Rivenhall IWMF EP Variation

Gent Fairhead

Schedule 5 Notice – Response

D WI BREF Sulphur Dioxide Data

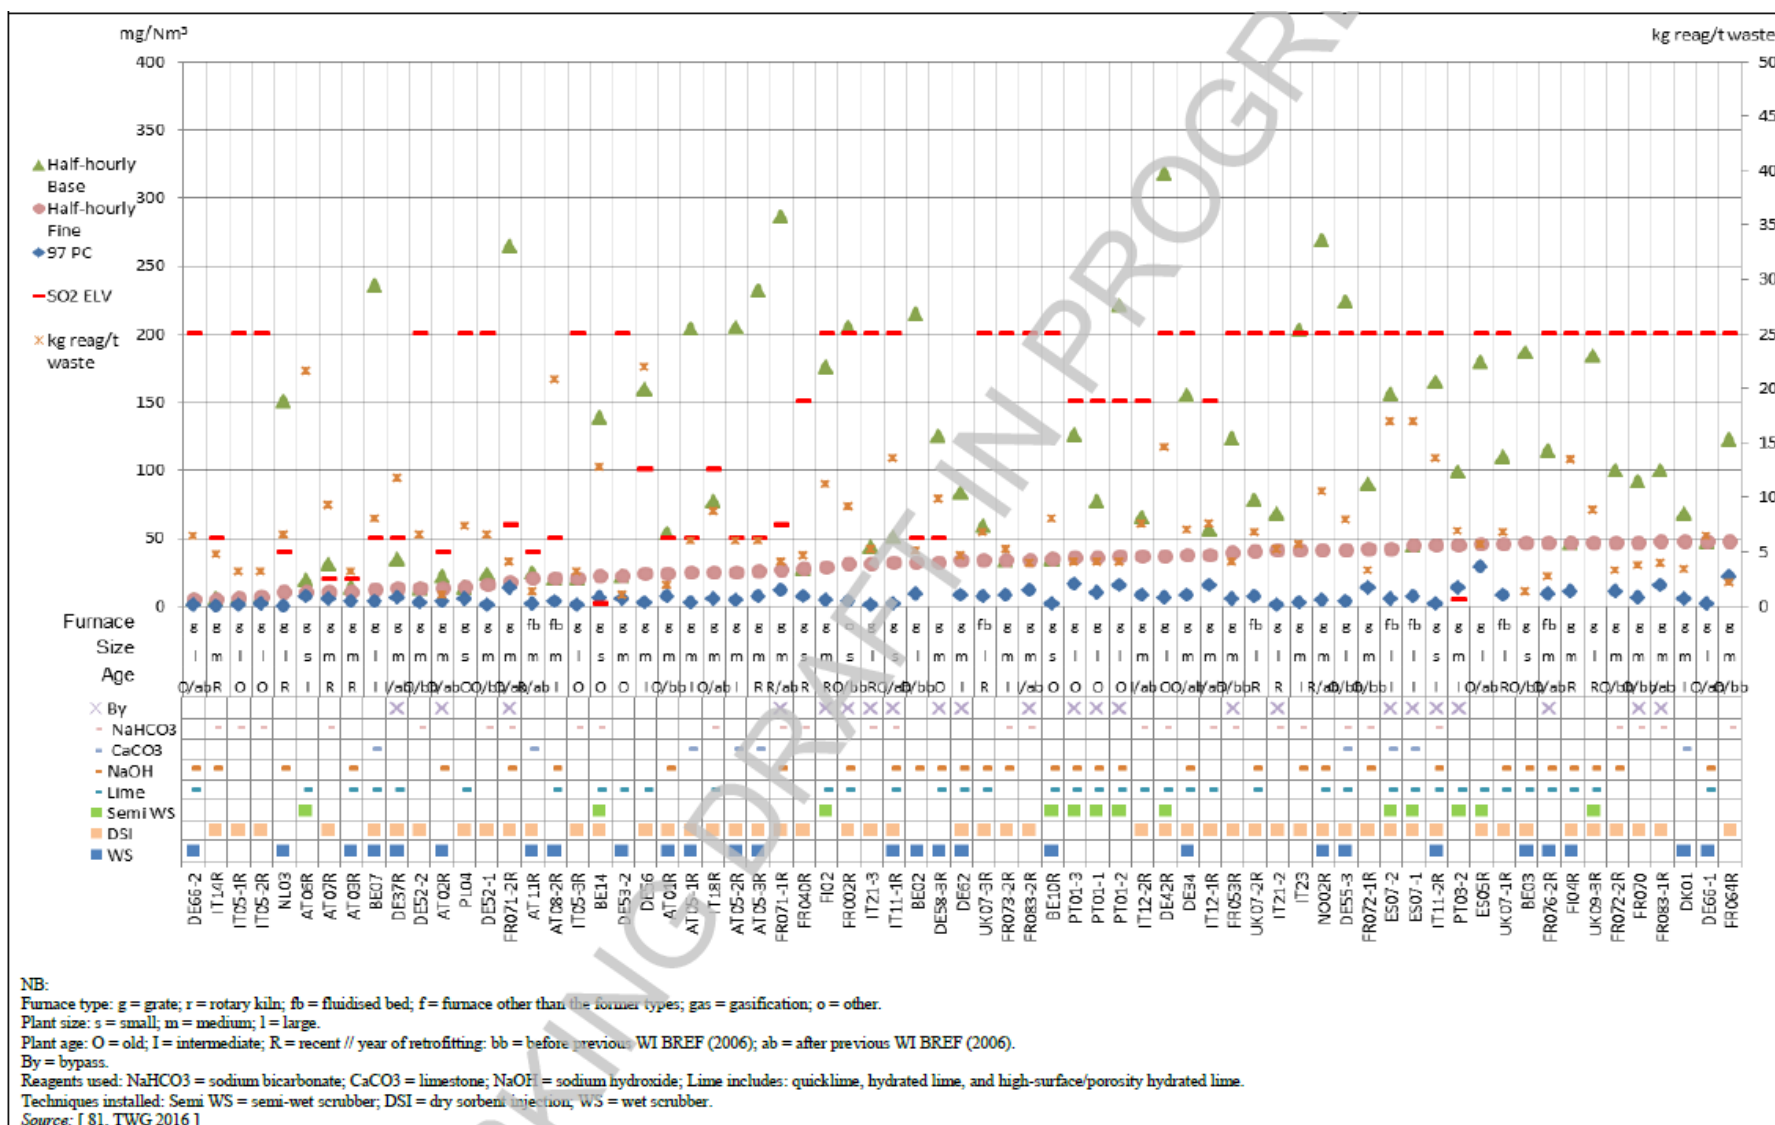
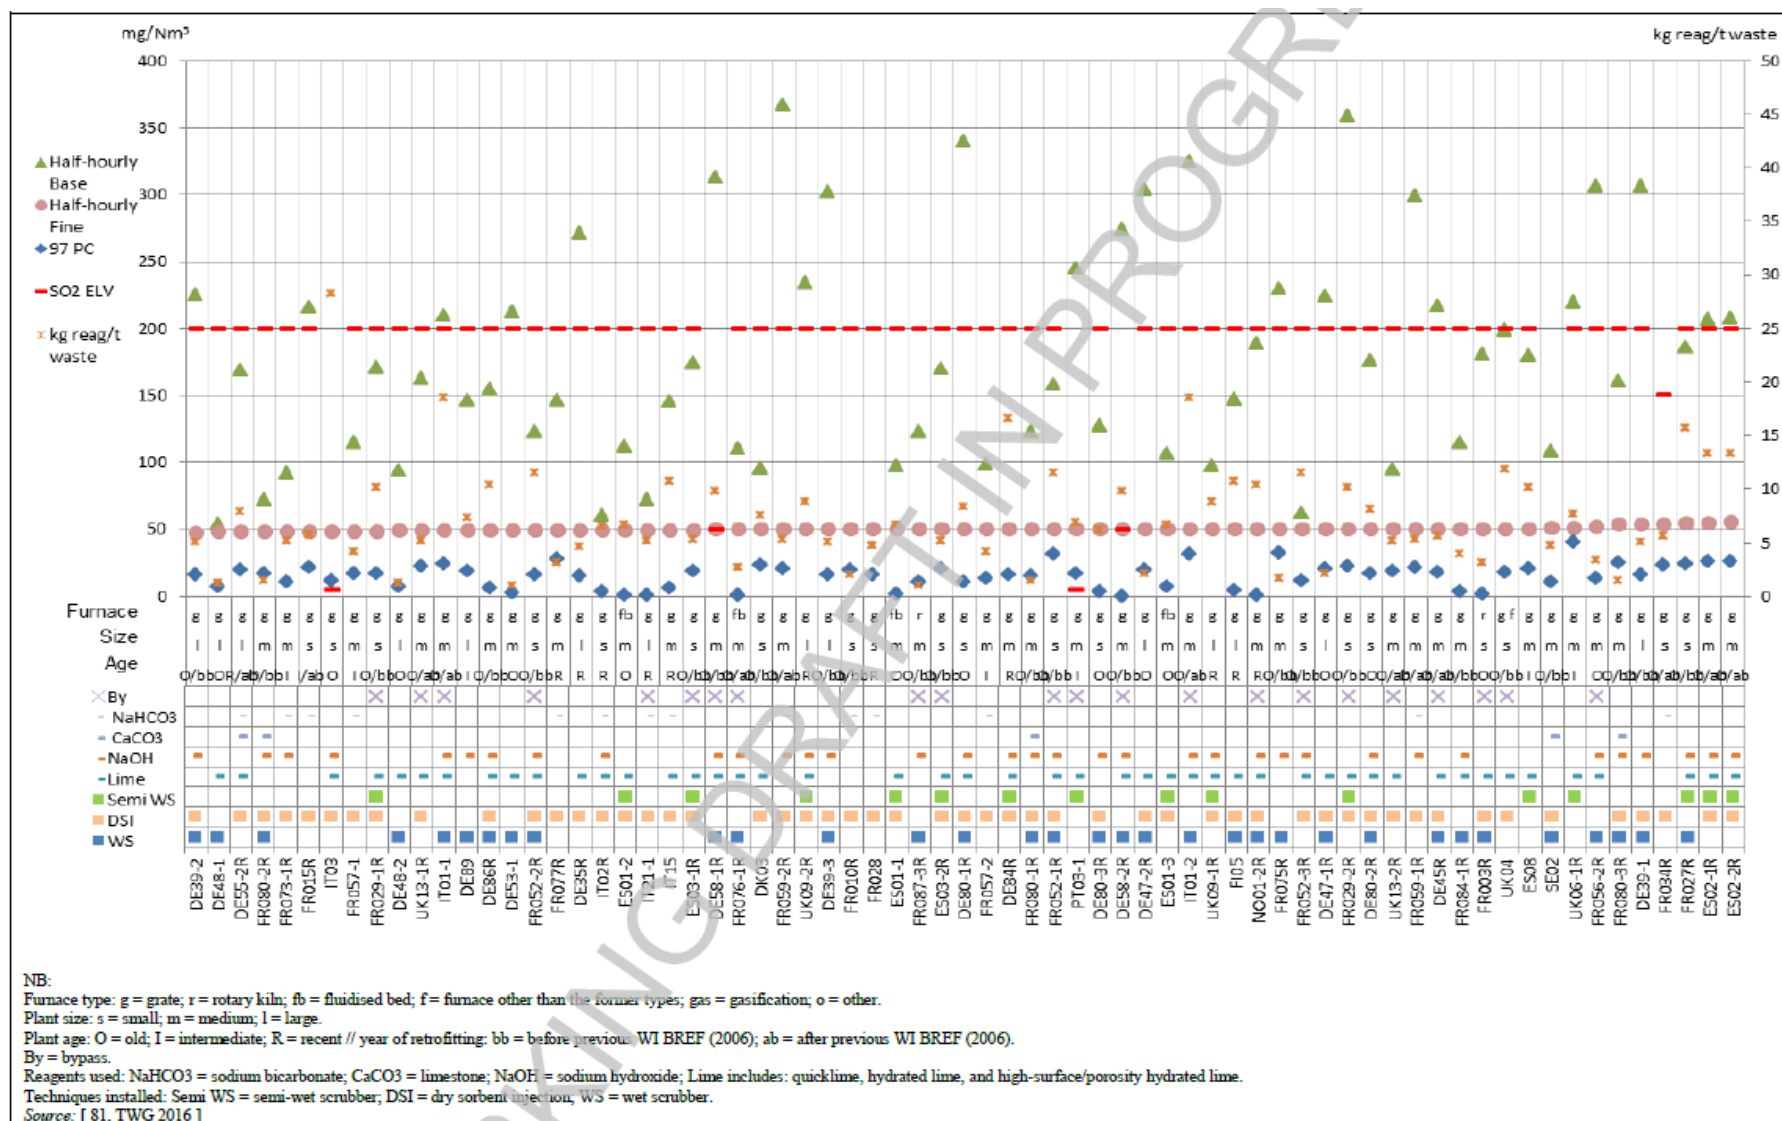
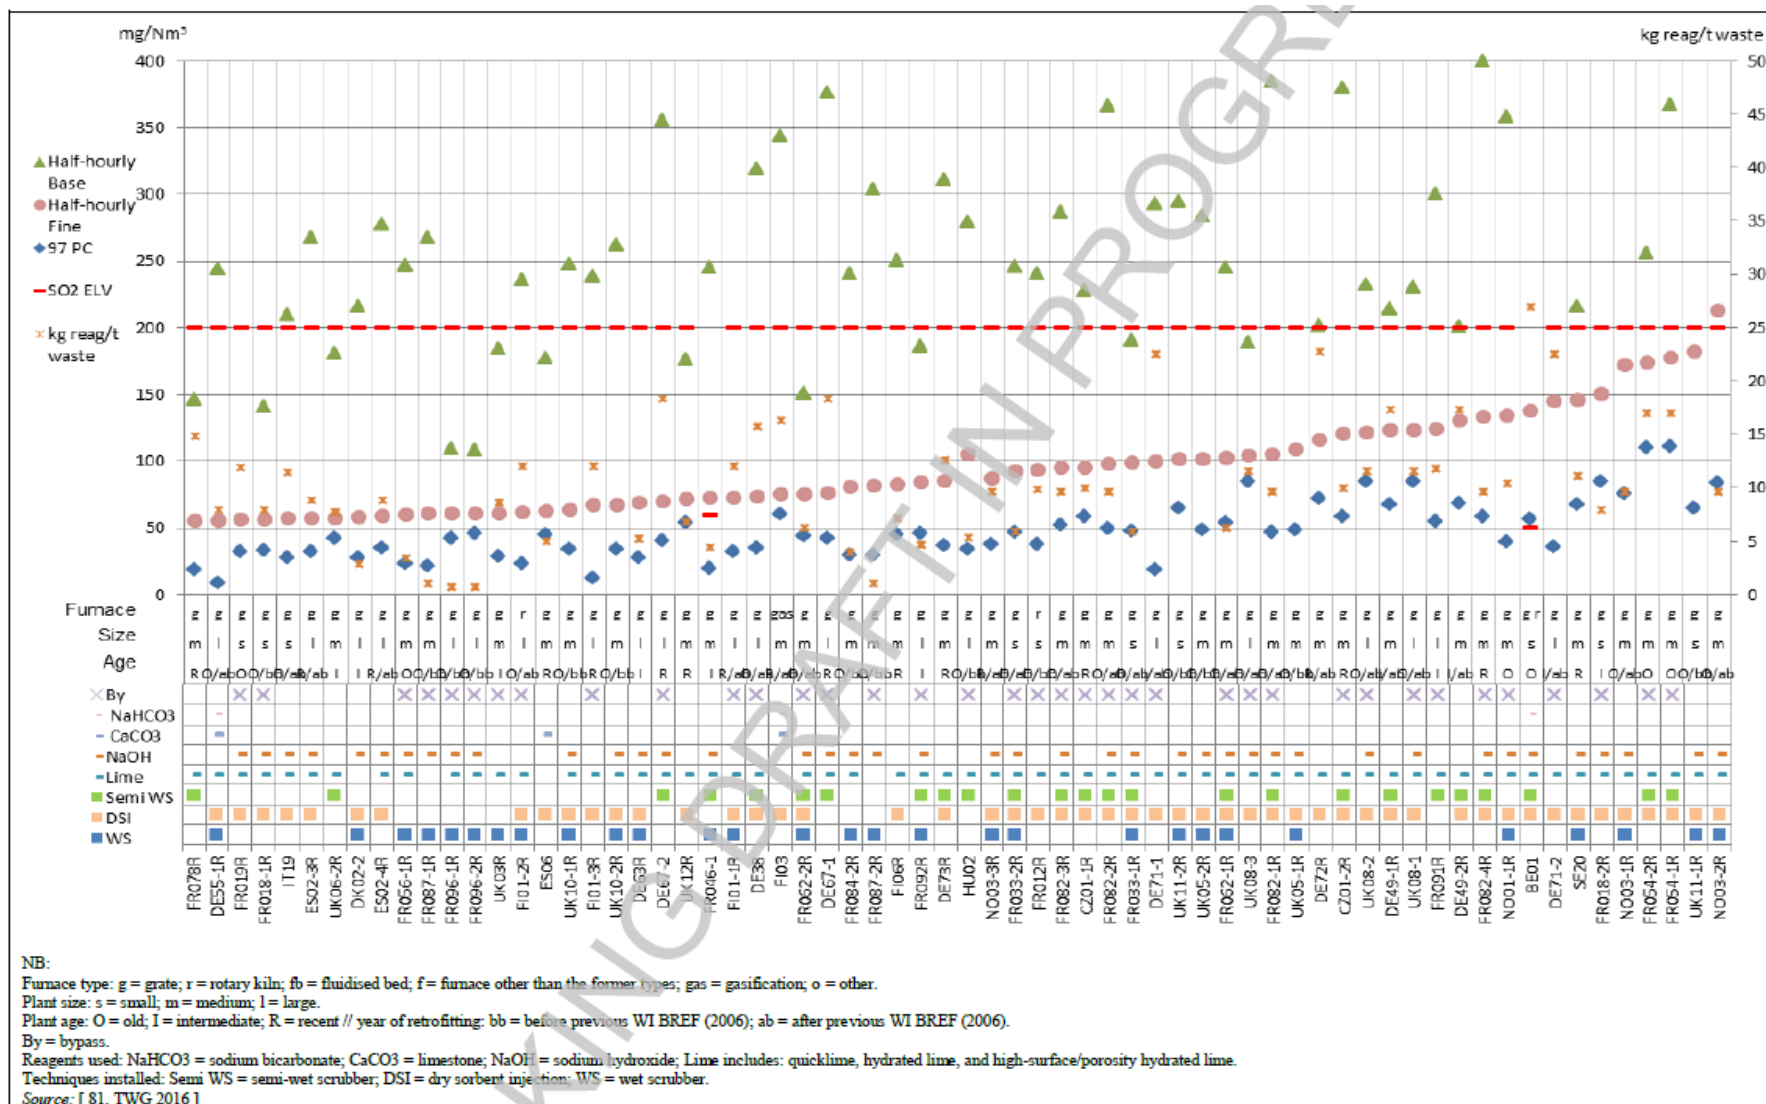
Demonstrate and provide evidence to support why the Applicant is confident this emission limit is now achievable and explain why emissions are now proposed to be lower than in the previous application.

The applicant is not aware of any other plant which is required to achieve a half-hourly emission limit of 90 mg/Nm³. However, as part of the process to develop the waste incineration BREF, a large amount of emissions data was collected and published in the final draft WI BREF. Figures 8.57, 8.58 and 8.59 summarise the half-hourly emissions of sulphur dioxide from 204 reference lines which predominantly burn municipal waste. These have been reproduced in Appendix D.

There is a lot of data on these graphs, but we wish to focus on the pink solid circles which show the 61st highest recorded half-hourly concentration of sulphur dioxide, excluding periods of abnormal operation. (The 60 highest figures are excluded, which covers around 0.03% of the 17,520 measurements over a year and so this shows the level which can be achieved for the vast majority of the time). It can be seen that this figure is below 90 mg/Nm³ for all of the lines on Figures 8.57 and 8.58 (and actually is at or below 50 mg/Nm³ for these lines) and below 90 mg/Nm³ for over half of the lines on Figure 8.59. There were only 32 lines for which the figure exceeded 90 mg/Nm³, and it should be noted that these lines were not required to achieve this figure.
